June 10, 2019

**RE: Response to Planning Division Staff Report
760-780 Regent Street**

EXHIBIT A

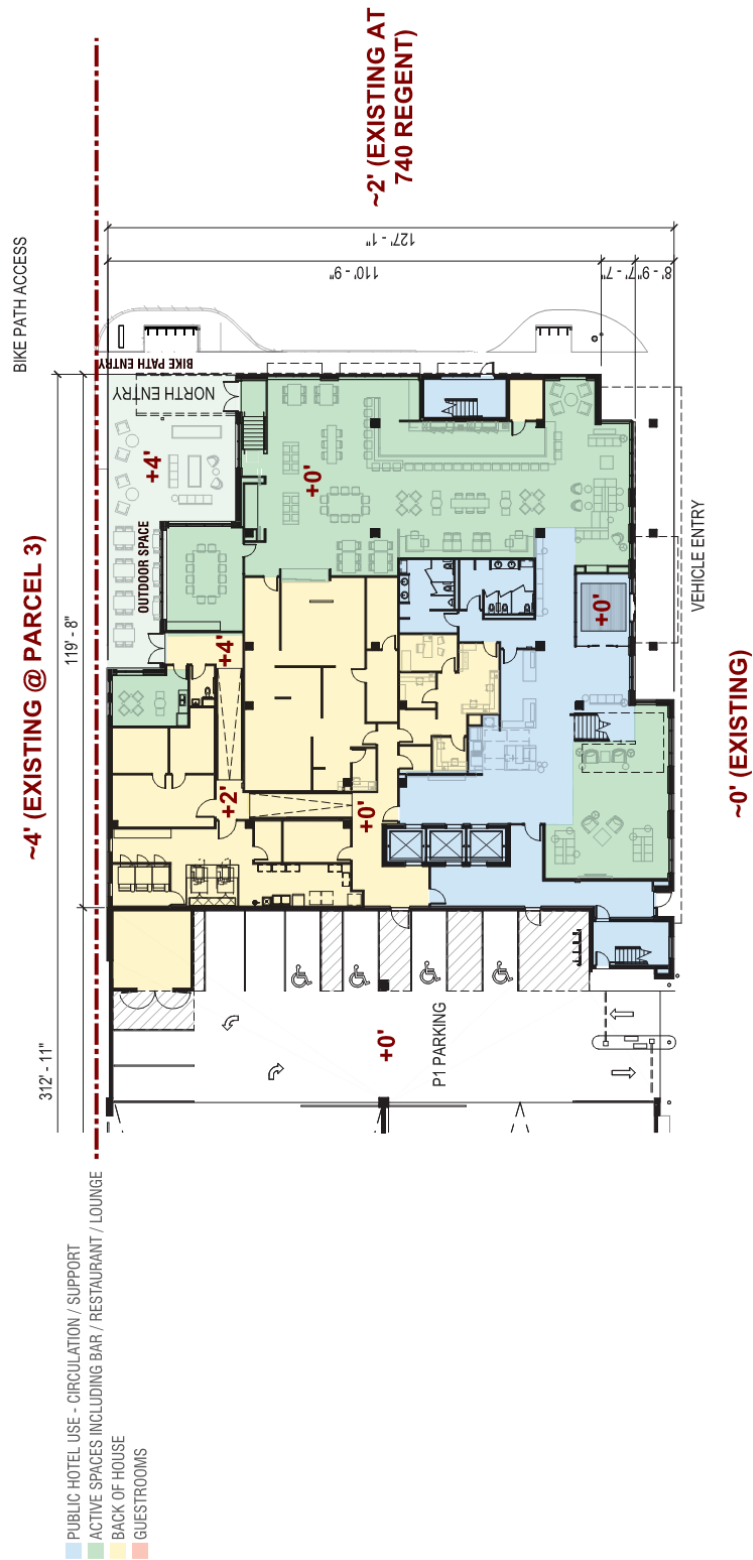
In response to staff conditions, we have raised the elevation of the northern building edge to eliminate our retaining wall requirement within the City leased area (see Exhibit A). We have limited the construction work required within the City leased area to minor grading and drainage, public utilities (sewer, sanitary, water, electric and gas), landscaping, sidewalk connections, construction staging and restoration of the surface parking lot area. Our team has discussed this scope of work with Mr. Doran Viste, City Attorney, who was amenable to this scope of work being done under the existing lease and was intending to relay this approach to Engineering staff and Traffic Engineering staff. The parking within the City leased area would no longer connect through the hotel parking structure, would be re-stripped (see Exhibit B for re-stripping options), and the intent is to use this parking for hotel employees only.
